REMARKS

EXHIBIT A

Amendment to the Drawings

FIG. 2

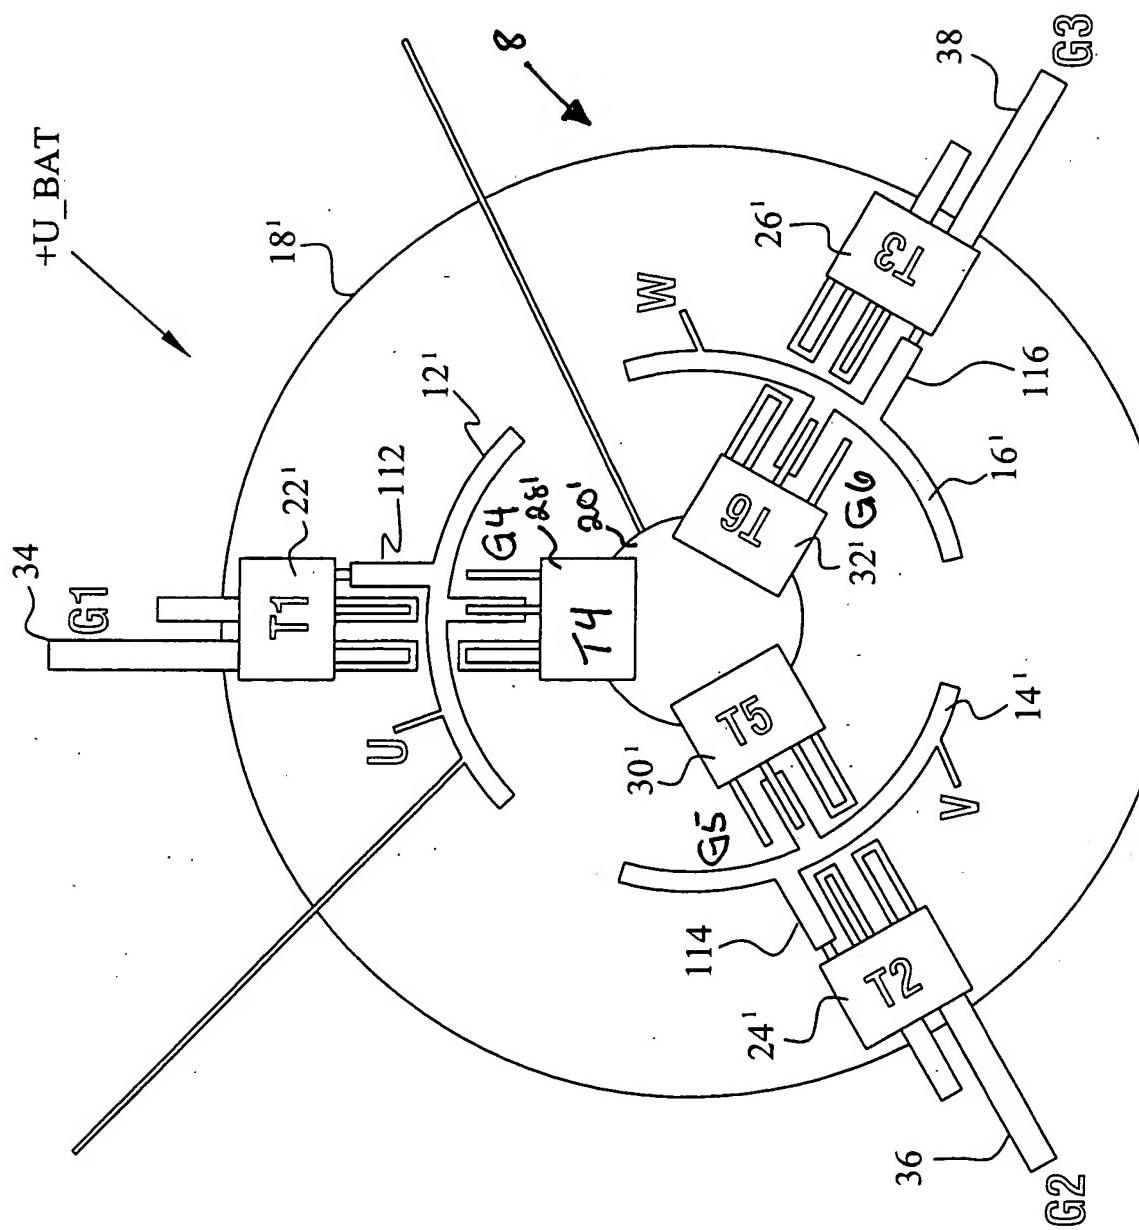
1. In response to Examiner's request to identify "The lead frame being rotationally symmetrical (U-phase has an additional lead line extending radially outward from the lead frame," Applicant has amended the claims to recite "substantially symmetrical". In addition, Fig. 2 has been amended to identify the lead lines extending from radially outward from tracks 18' and 20' as 118 and 120, respectively. Lead lines 118 and 120 are identified in claim 4 for connecting tracks (18', 20') with the positive and negative power supply sources. Support for this amendment is found, for example, at Fig. 1 and at page 4, lines 16-21 of the specification.

Attached hereto is Exhibit A a courtesy copy of a previously-filed Replacement sheet and Annotated Marked-up Drawing showing amendments to Figure 2. Figure 2 was amended to correct informalities identified by the examiner. No new matter has been added.
